Our Ref: CD22-024/Auth

Council Application Reference: A006183488

**RE: BRISBANE CITY COUNCIL - FURTHER ADVICE REQUEST**  
**PROPERTY ADDRESS: 50 RETREAT ST BRIDGEMAN DOWNS QLD 4035**  
**PROPERTY DESCRIPTION: LOT 2 ON SP178844**

# 24 Lots Residential Subdivision DA

**Figure 1 – External Treatment Area**

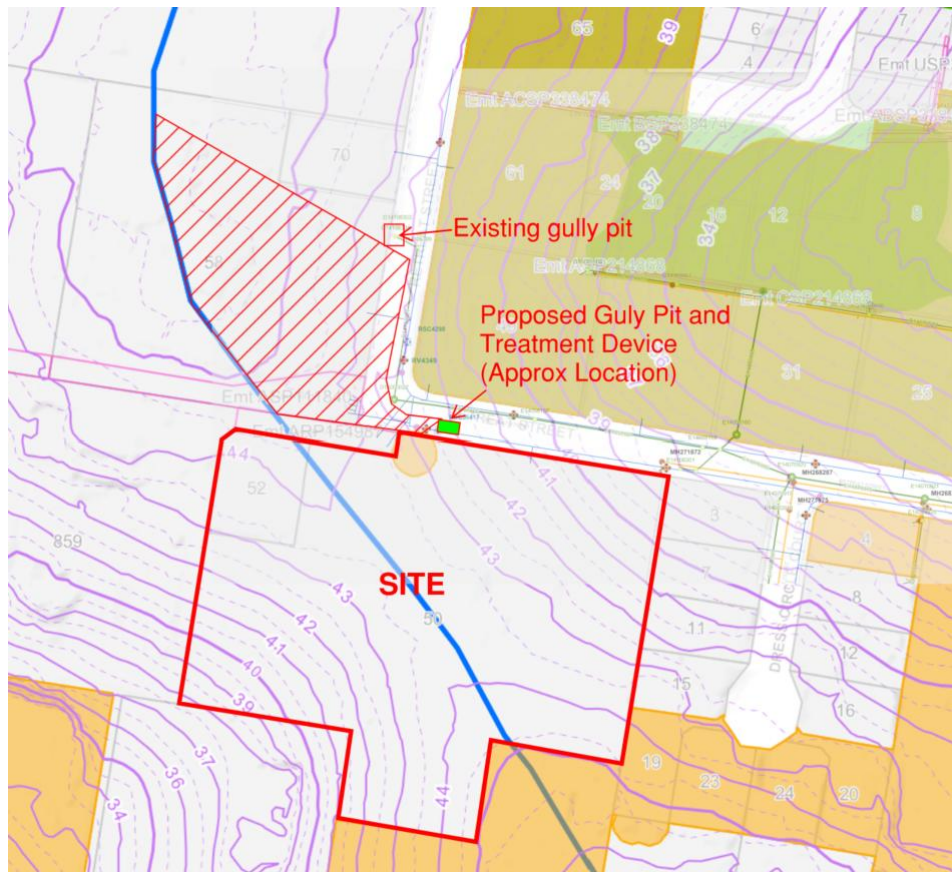
- Additional, external treatment: In addition to WaterSmart Street Tree's strategically located within the development, we propose an additional gully pit with and an upstream WaterSmart Street Tree on Retreat St,

prior to the intersection with the new road. The nominated location will treat a significant external catchment with respect to Stage 1. Refer Figure 1 below.

### Stormwater WSUD Tree Bio Retention Plan

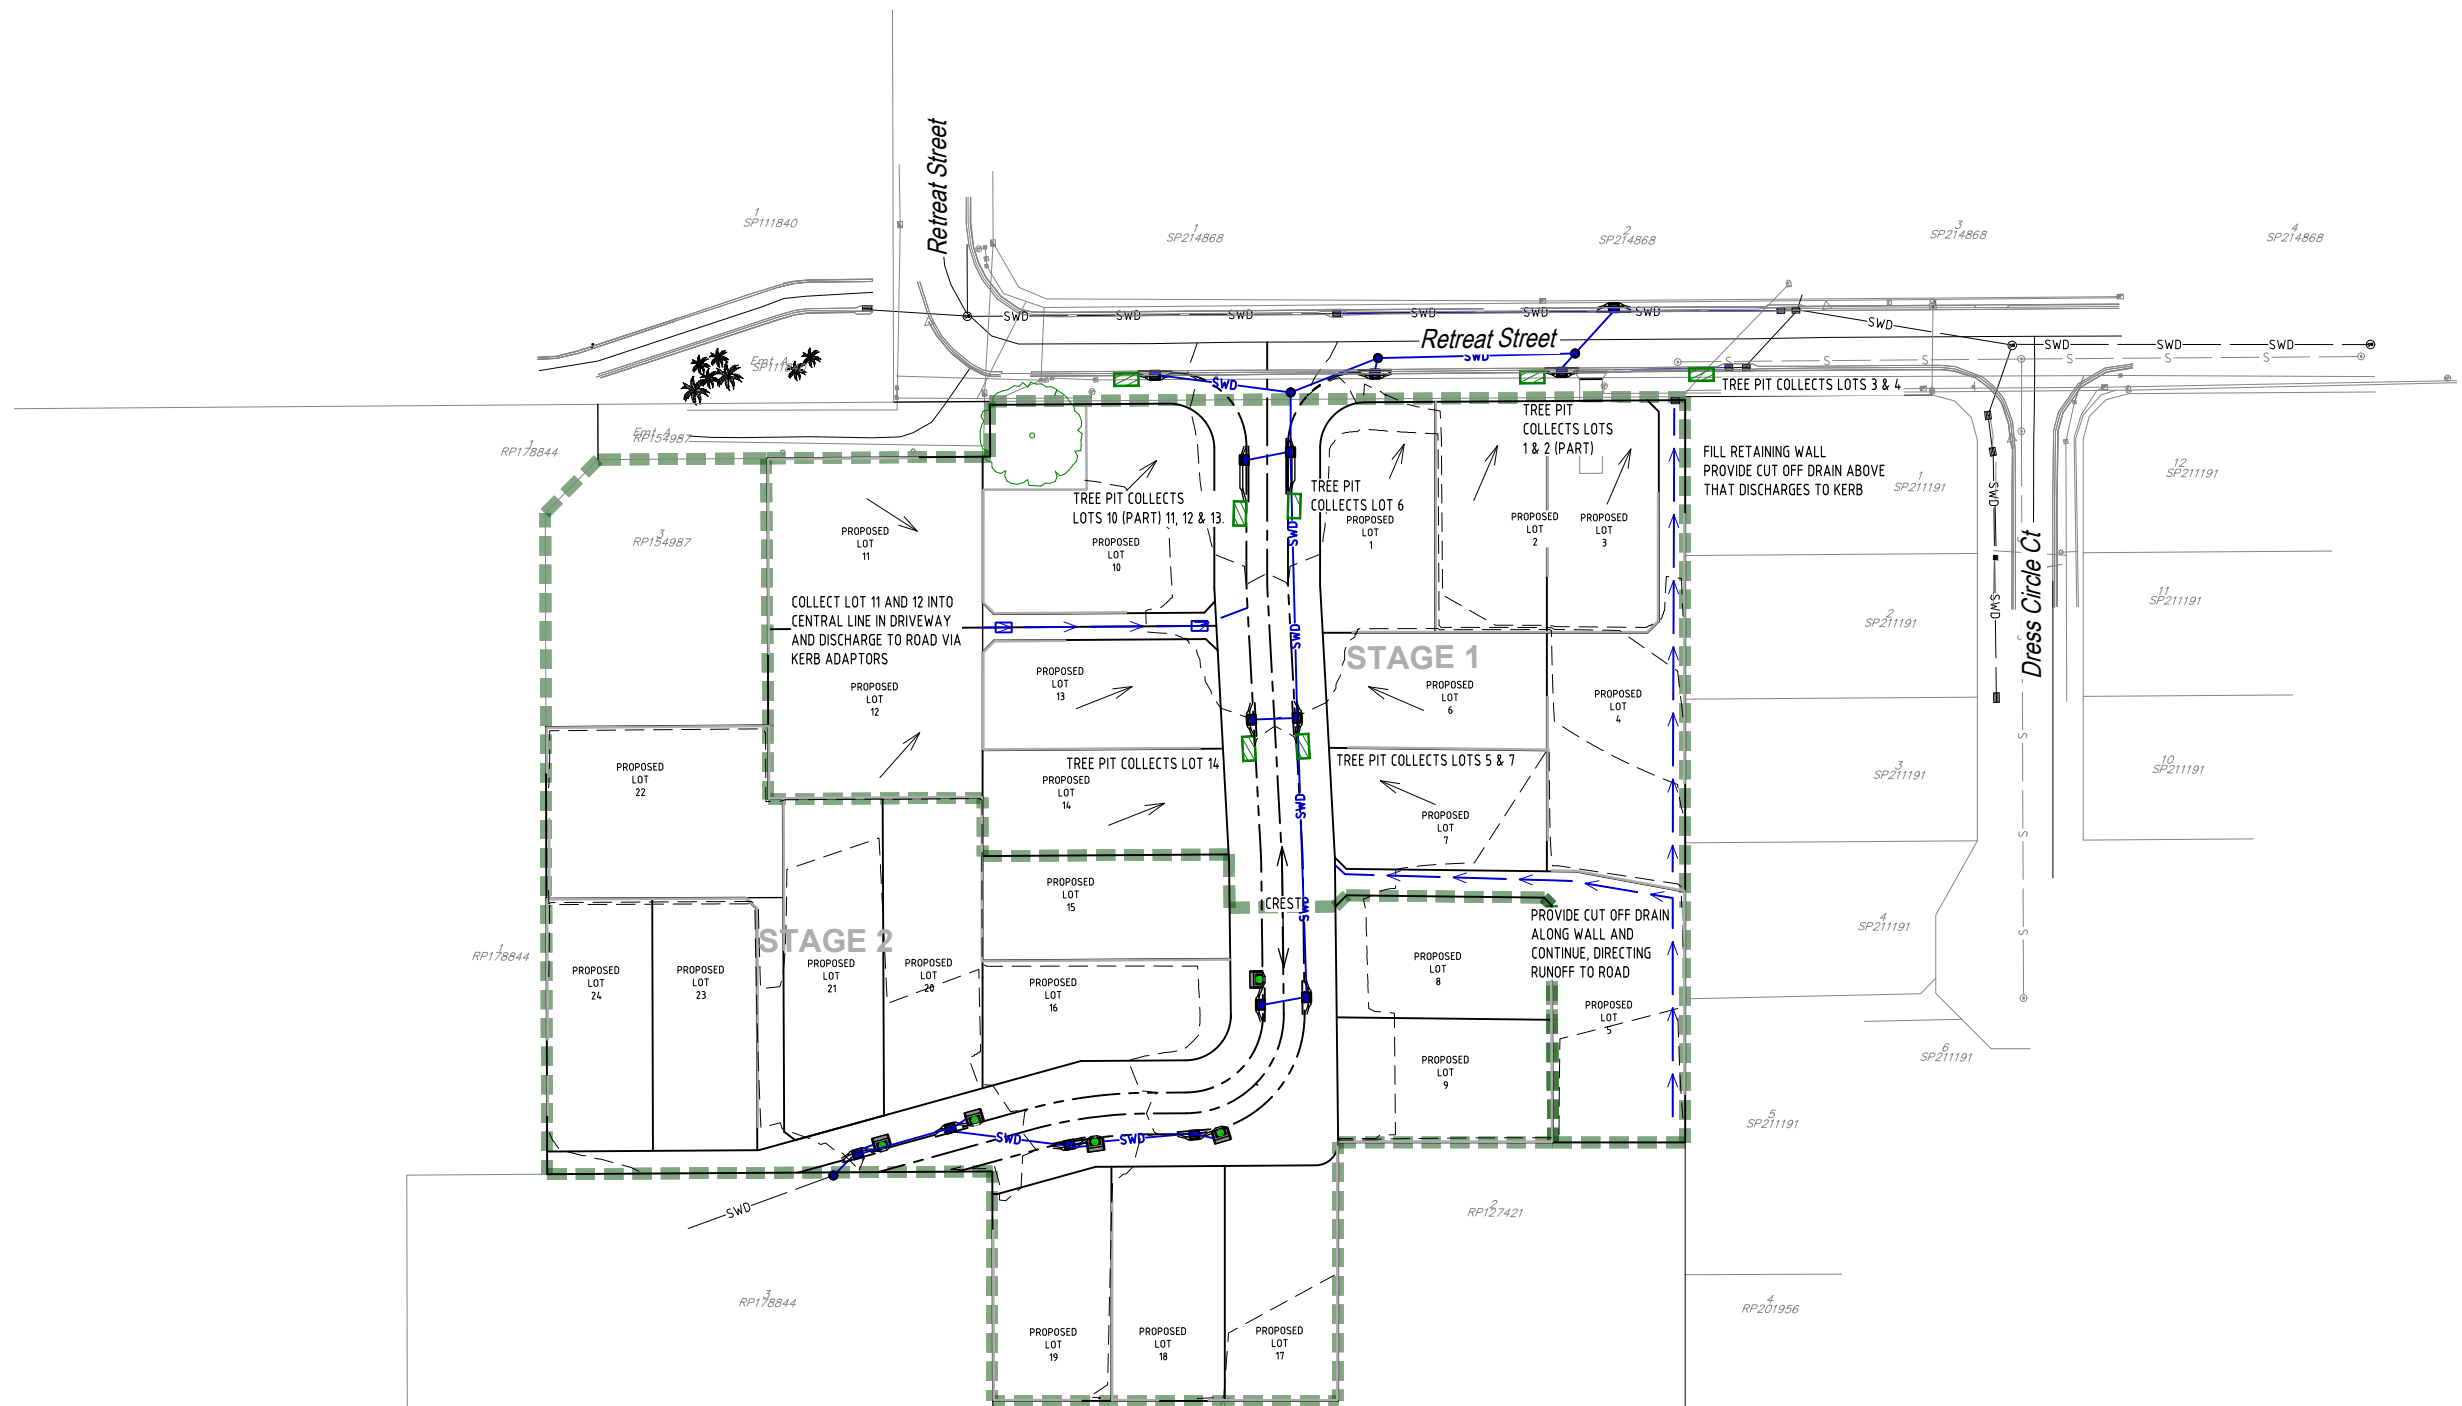
*The proposed plans continue to show a layout which does not provide a bio-retention basin for either of the Stage 1 or Stage 2 catchment areas. Council has reviewed the Site Based Stormwater Management Plan, and whilst the comments provided are noted; Council maintains that a bio-retention basin is required to treat the stormwater flows generated by Stage 1 of the development in lieu of the proposed WaterSmart Street Trees; due to the number of lots delivered as part of this stage.*

- a. *Submit a revised Site Based Stormwater Management Plan signed by an RPEQ, and revised plans showing a bio-retention basin provided to service and treat the stormwater flows from the proposed Stage 1; in accordance with the Stormwater Code PO6*
- b. *If the lawful point of discharge issue can be addressed for the proposed Stage 2, the revised Site Based Stormwater Management Plan, and revised plans must show WaterSmart Street Trees limited to 1 x tree at any location, and the minimum catchment to be 2 x lots per WaterSmart Street Tree; in accordance with the Stormwater Code PO6.*

- Given Stage 1 has the same number of lots and similar runoff requiring treatment, we believe the preferred solution is to propose WaterSmart Street Tree's in Stage 1, similar to Stage 2.

We have prepared a plan which shows proposed locations for WaterSmart Street Tree's with due consideration to respective catchments, refer attached Drg CD22-204-SK01.
